Re: Basin Disposal, Inc. and Pasco Sanitary Landfill, Inc.'s Comments on Draft
Consent Decree, Pasco Landfill NPL Site

On behalf of Basin Disposal, Inc., ("Basin") and Pasco Sanitary Landfill Inc., ("PSLI") we provide what follows as Basin and PSLI's comments upon the draft Consent Decree and the accompanying dCAP (draft Cleanup Action Plan) and SOW (Scope of Work) with regard to the Pasco Sanitary Landfill ("PSL").

EXHIBIT 6

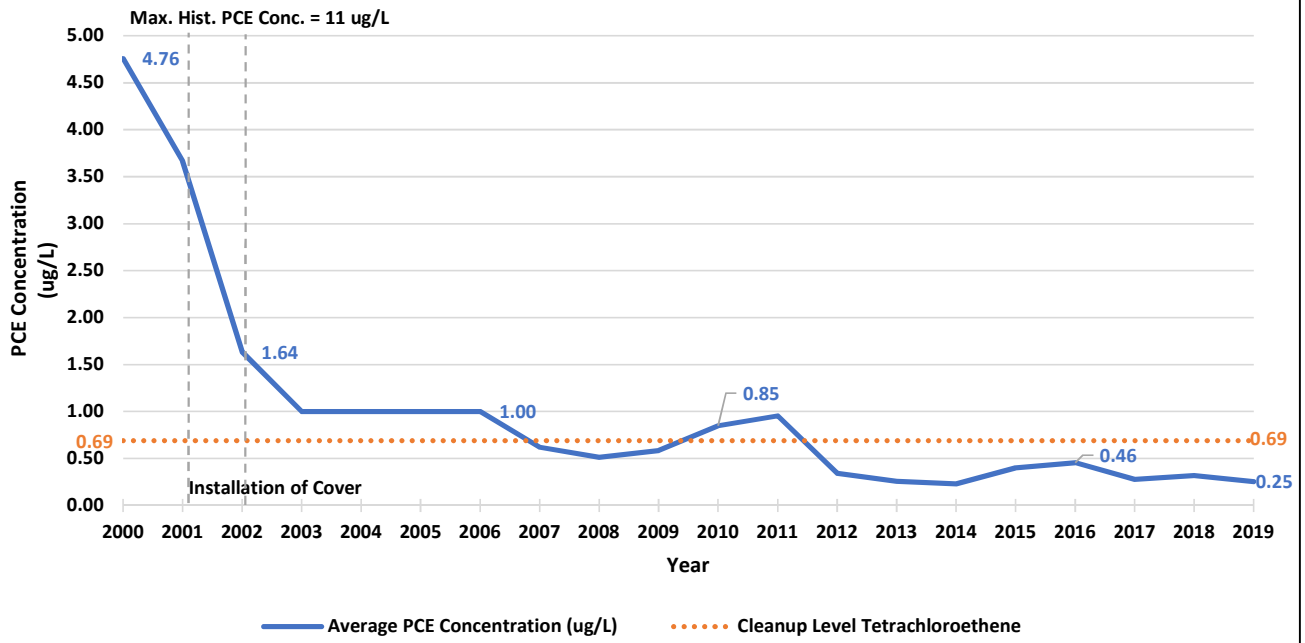
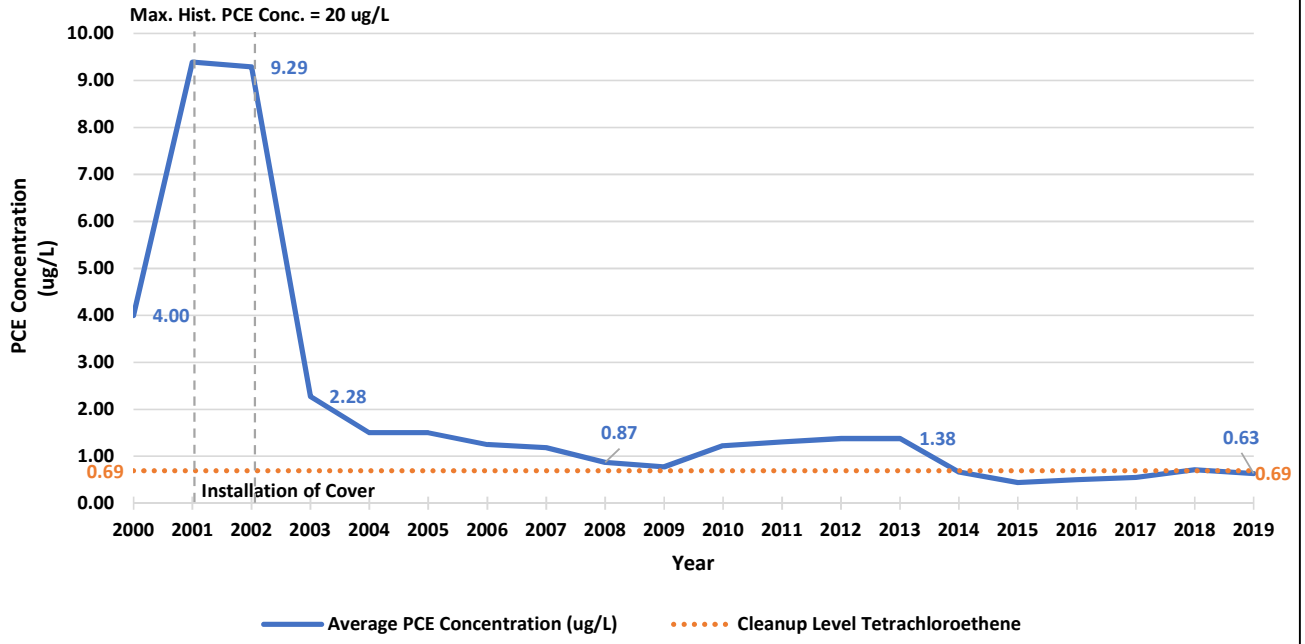
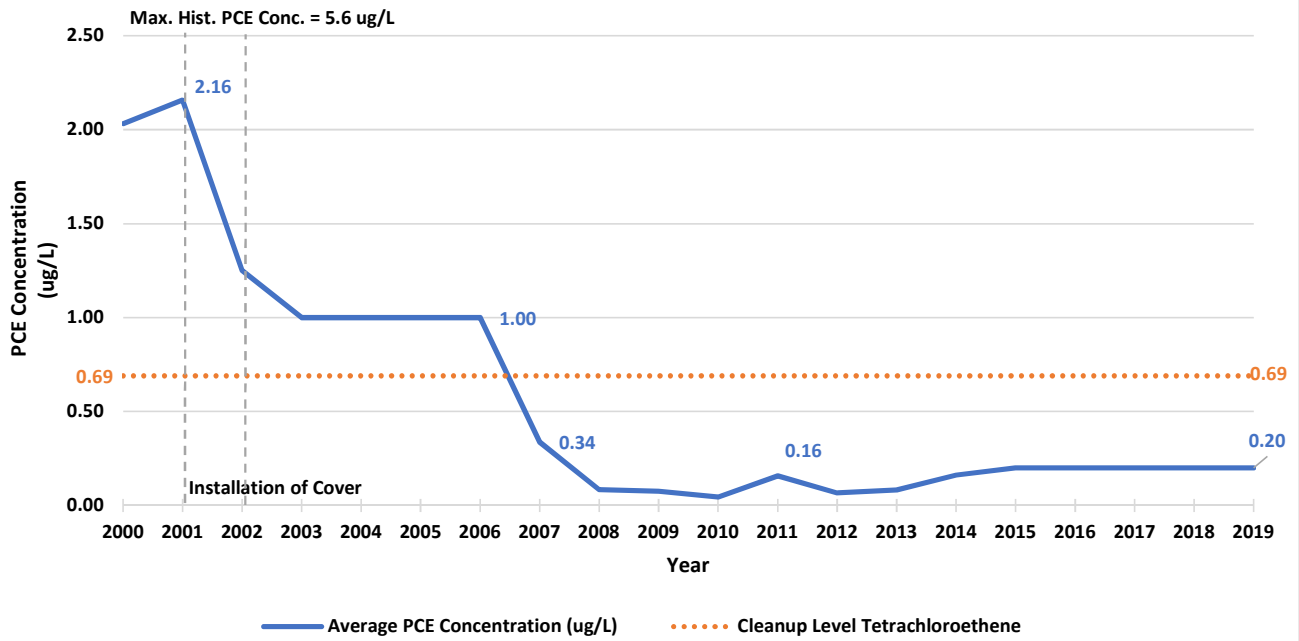
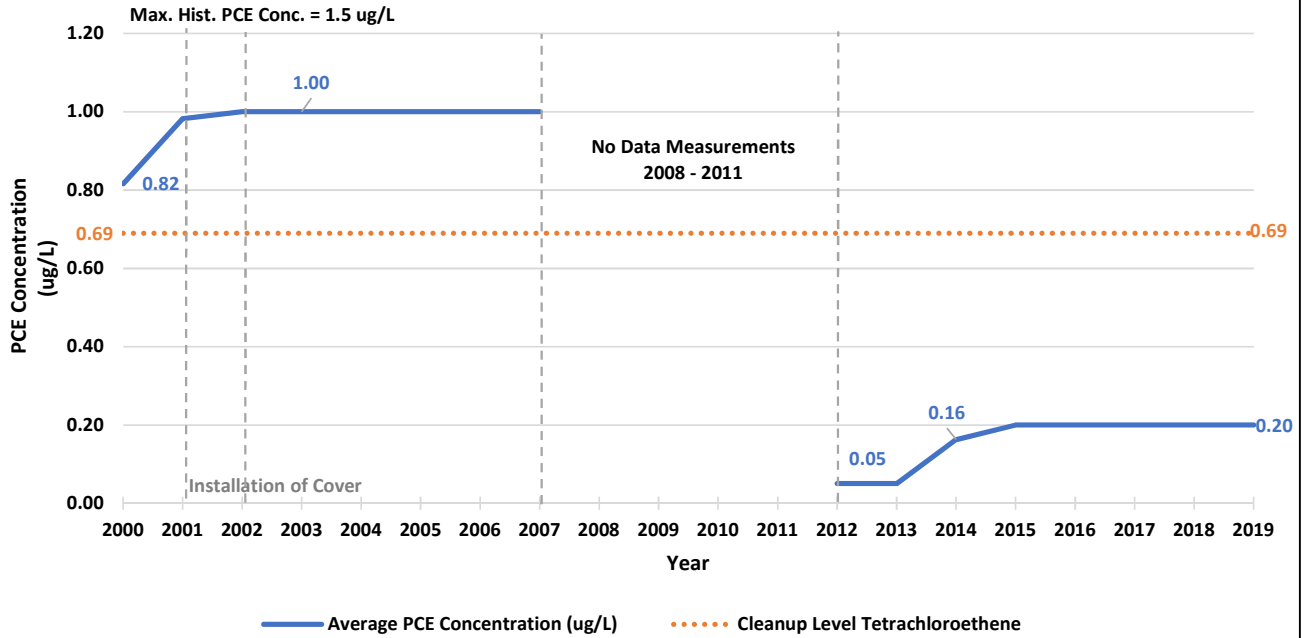
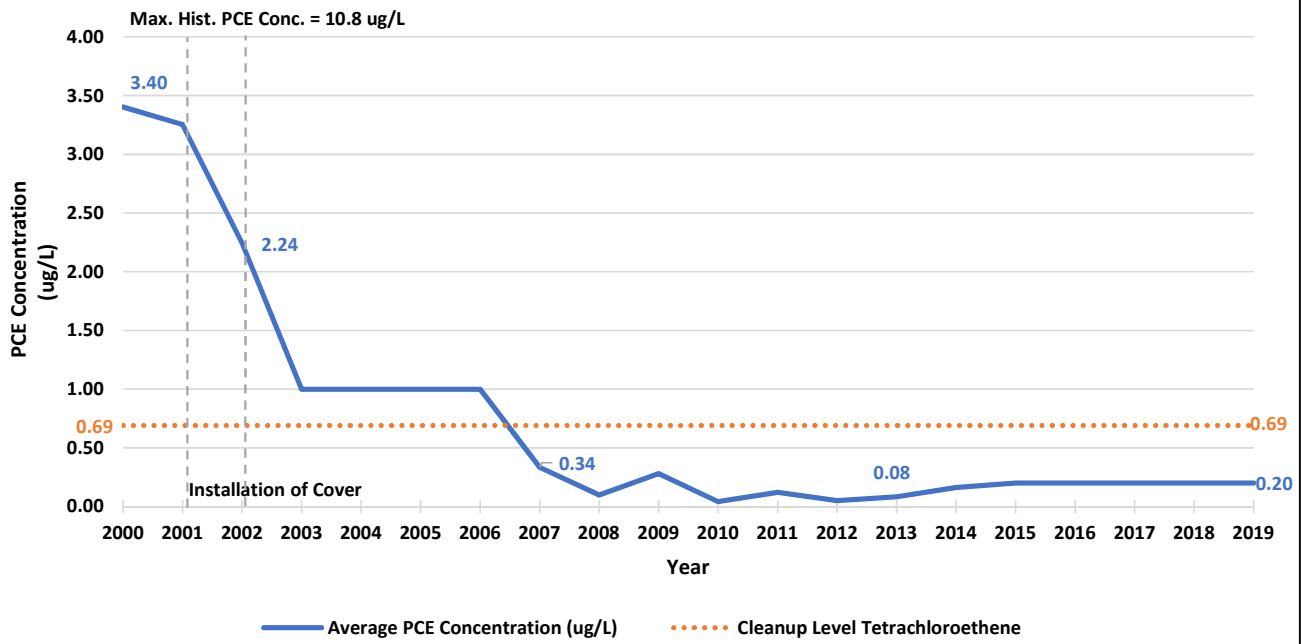
Excellent progress has been made in remediating the small amounts of PCE present at the MSW as well, though PCE remains at slightly above cleanup levels in a single well, presently. If, as expected, PCE levels continue to drop consistent with their long-term declining trajectory, Basin and PSLI expect PCE levels to drop below cleanup thresholds in the next few years. These trends are depicted, across five different wells in the MSW, in Exhibit 6.

EXHIBIT 9

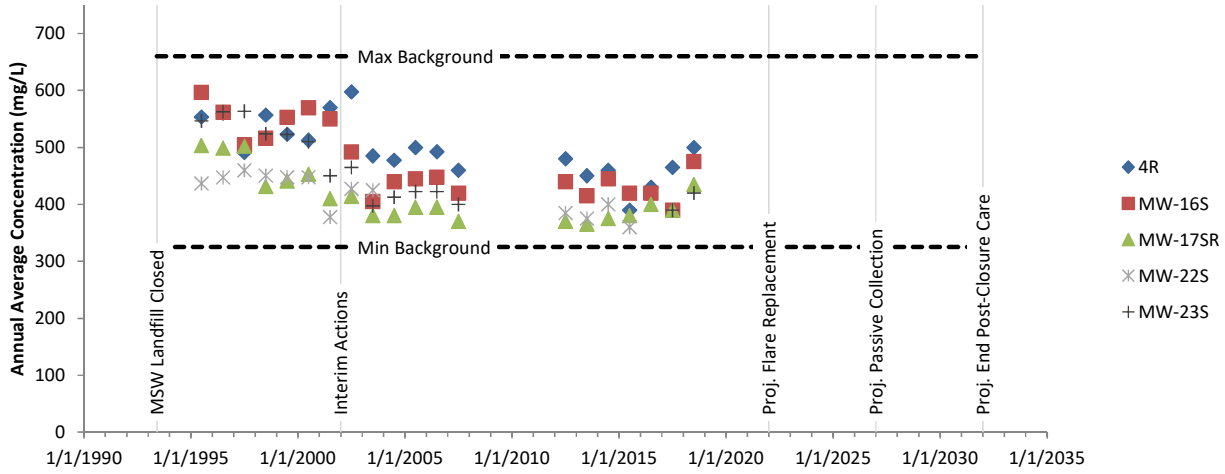
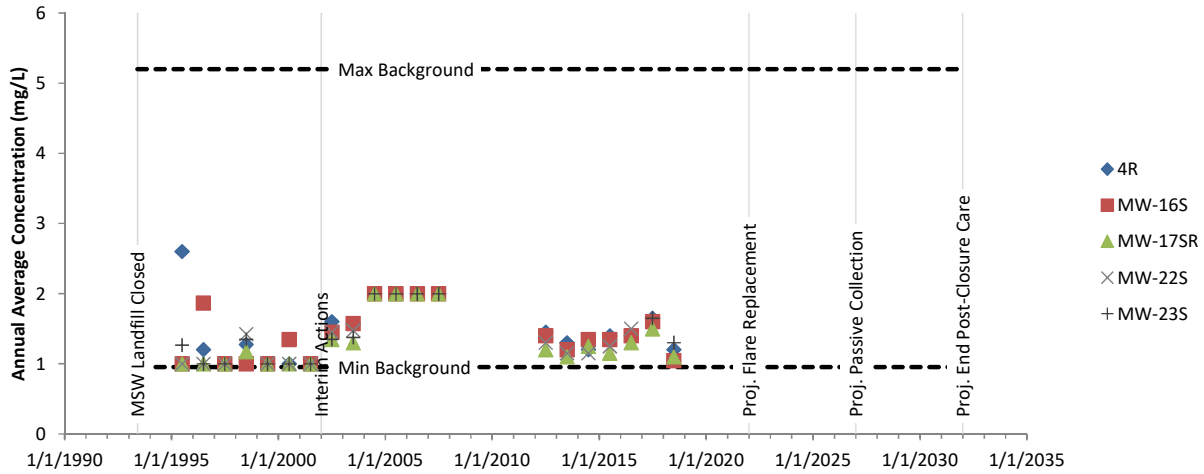
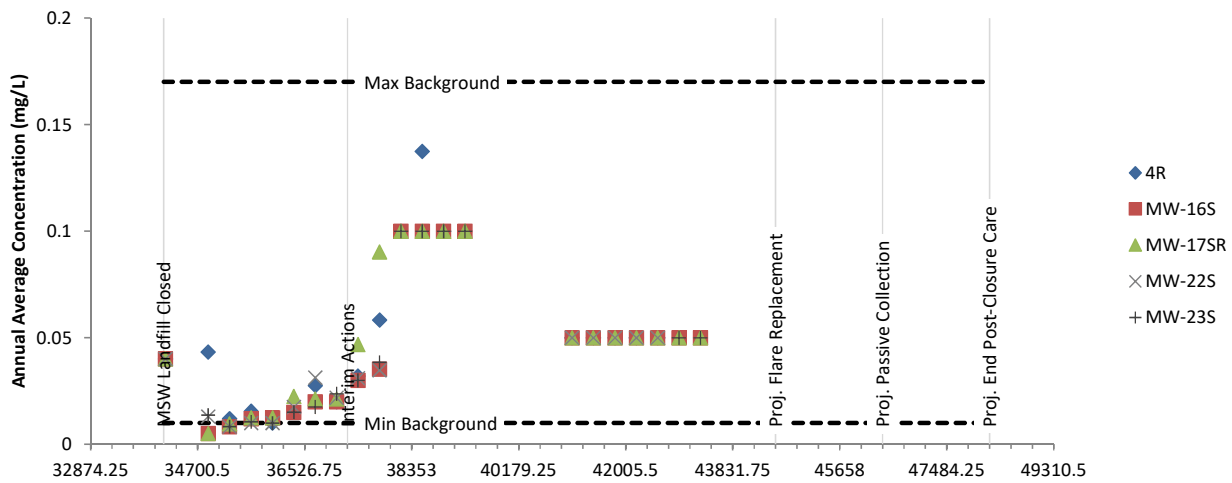
Groundwater conditions downgradient of the landfill have been within the natural variability of the aquifer. The maximum background concentrations for total dissolved solids (salts), total organic carbon (non-toxic decomposition byproducts), and ammonia reflect land use upgradient. If groundwater downgradient had higher concentrations than the maximum background concentrations, or increasing trends, it would indicate a potential source of leachate from the landfill. Thus, there have been no leachate impacts from the MSW landfill historically. The risk of leachate production in the future is lower than in the past due to aging waste and excellent cover system performance keeping water out of the waste, yet another consistent marker of the efficacy of the present cover. We expect no future leachate impacts from the MSW landfill.

These results are shown in the collection of figures at Exhibit 9.

EXHIBIT 11

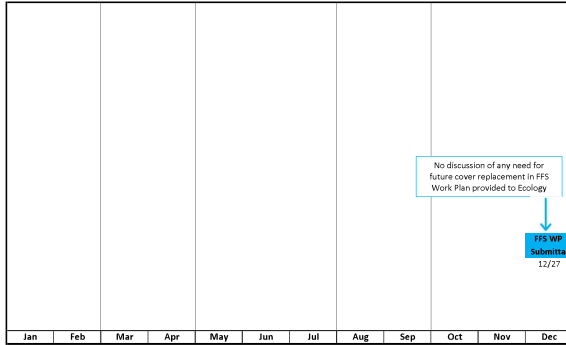
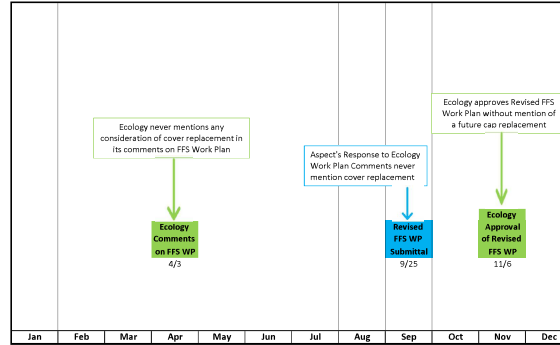
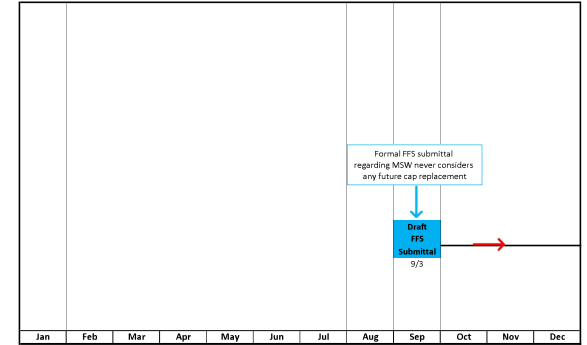
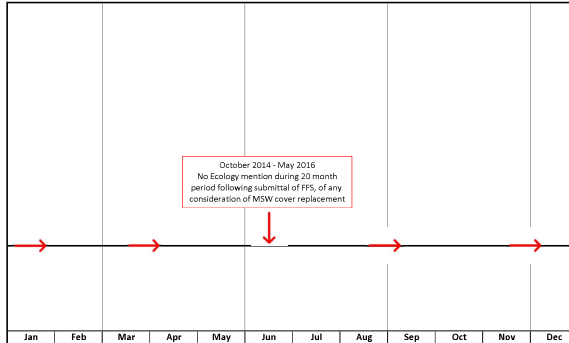
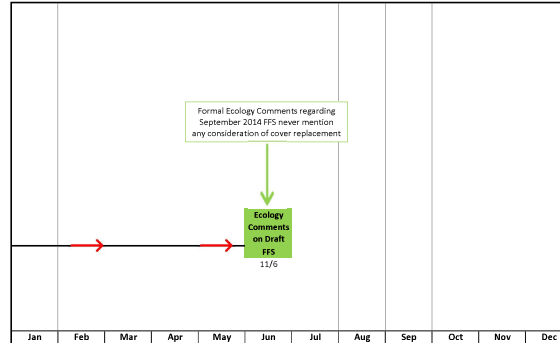
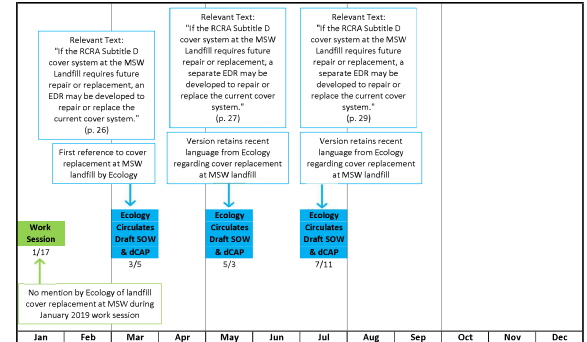
Basin and PSLI have examined the history which brought us to the present and were witness to Ecology's very recent expression that the Consent Decree SOW/dCAP should include language suggesting the MSW cover may need future replacement. As the timeline in Exhibit 11 makes clear, this mandate appeared from nowhere, and was never raised at any time earlier when the suggestion now made could have been scientifically vetted, the cover could have been tested, and any claim that the cap might need replacement in the future could have been disposed of definitively.

Exhibit 11 calls out these events in a timeline which showcases the points Basin and PSLI make, above.
